PLANNING COMMISSION AGENDA

Tuesday, May 19, 2015
Breckenridge Council Chambers
150 Ski Hill Road

Miller-Huntress
Restoration
309 South Main Street

Planning Commission Staff Report

EXISTING CONDITIONS SITE PLAN - PARKING PLAN

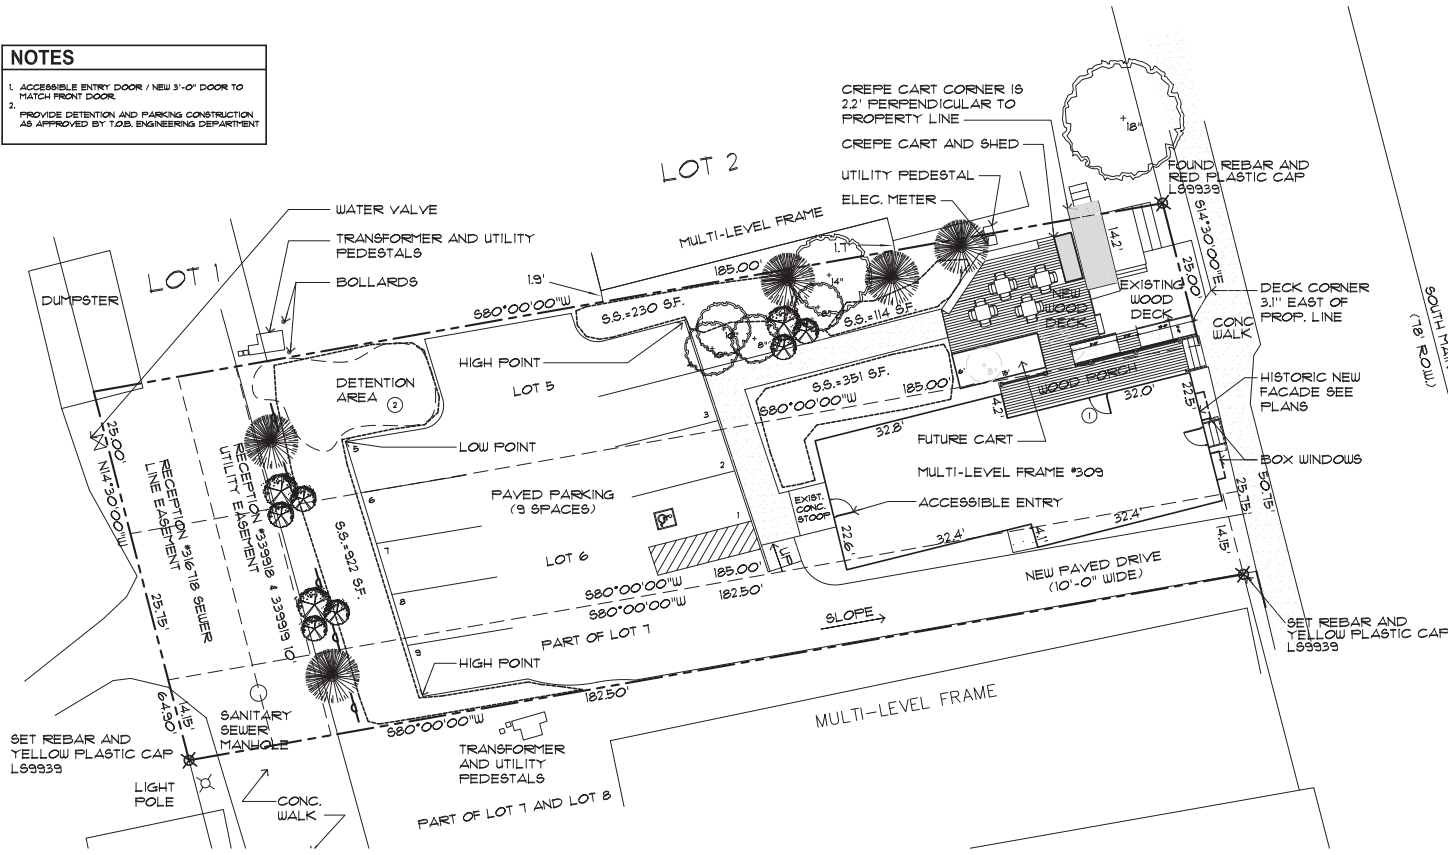
Site Plan/Parking: There is an existing parking lot behind the building with thirteen (13) spaces available. A restaurant use requires more parking than retail. Due to the change of use from retail to a restaurant, an additional 2.25 parking spaces (1,065/1,000 = 1.07 SFE's x 2.1 (3.5 – 1.4 credit for retail) = 2.25 are required per Section 9-3-8 of the Town's Off-Street Parking Regulations.

In 1992, eleven (11) onsite spaces were proposed (including one handicap accessible site) and ten (10) spaces were purchased into the parking service area in lieu of providing parking on site. Upon visiting the site, staff counted fourteen (14) on-site parking spaces. However, none of the parking spots are currently handicap accessible, so as part of this application, it is required that the parking lot be reconfigured to provide at least one handicap accessible parking spot with accessible access to the building. This will bring the total on-site parking to thirteen (13) spaces which is two (2) spaces above the originally approved eleven (11) spaces. Given that this change of use requires 2.25 additional parking spaces, the property is deficient .25 parking spaces and therefore the applicant must pay an in lieu parking fee of **\$5,072.00** (.25 x \$20,288) per Section 9-3-12 of the Town's Off-Street Parking Regulations.

8. **The applicant shall provide the Town of Breckenridge Planning Department an updated parking plan to include one (1) handicap assessable parking spot.**

SP1.1
EXISTING CONDITIONS SITE PLAN
OF: 5

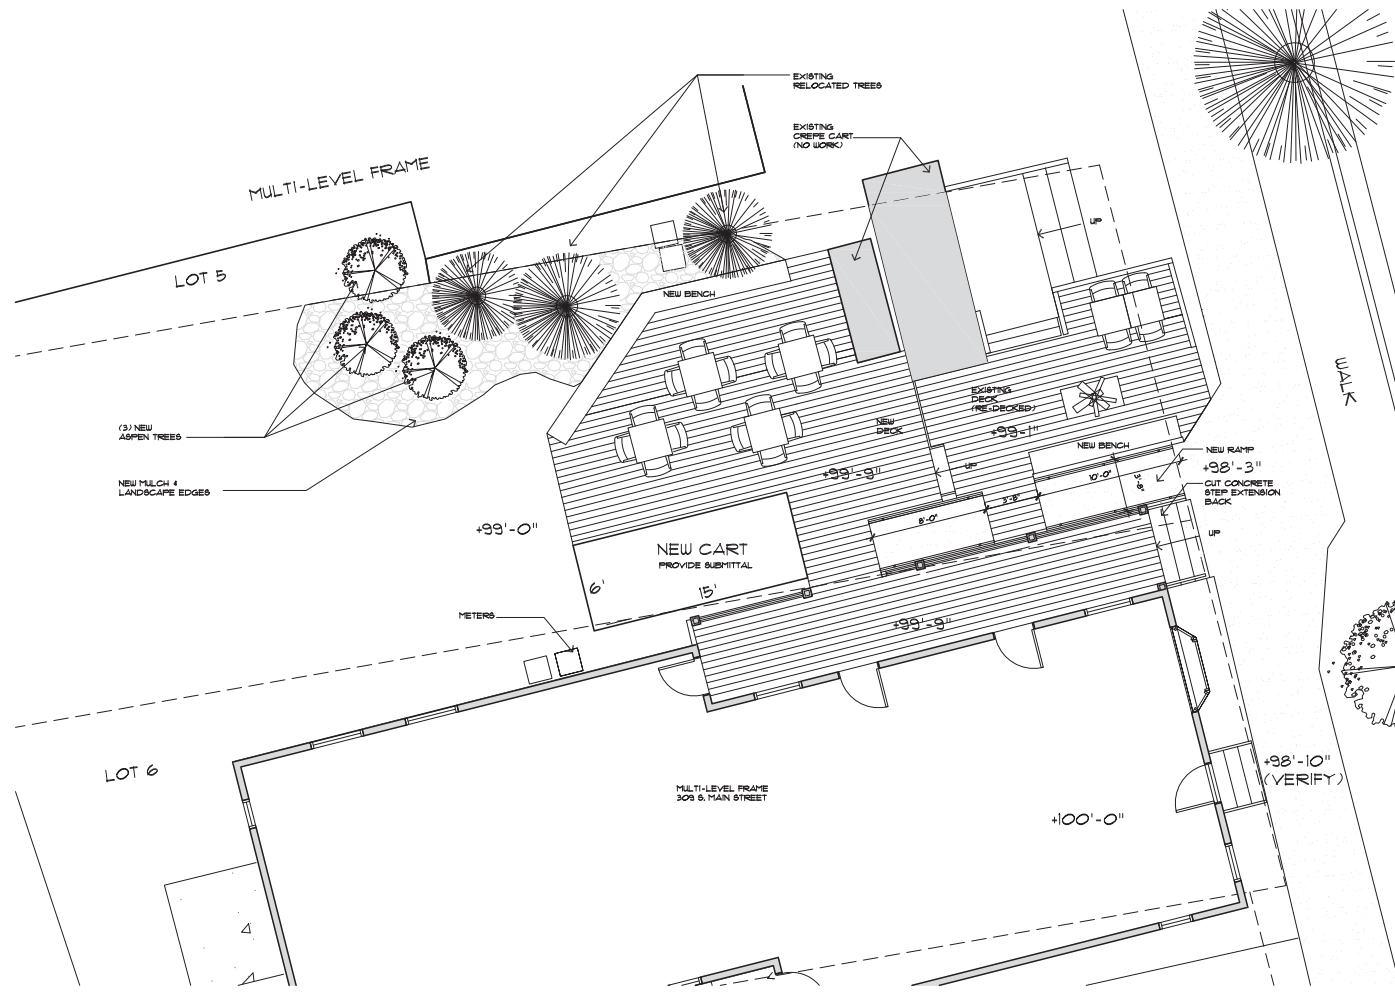
There will be a condition of approval that if the three (3) spruce trees that are to be moved die, they will have to be replaced on a caliper per caliper basis with new spruce trees. All three areas that are shown as snowstack (S.S. on plans) will need to be revegetated, with native grass seed or sod and cannot be left un-vegetated, which would not meet the requirements of Riverwalk compatible improvements or the landscaping policy. Staff requests these areas be labeled as reseeded or sod prior to the final hearing submittal.
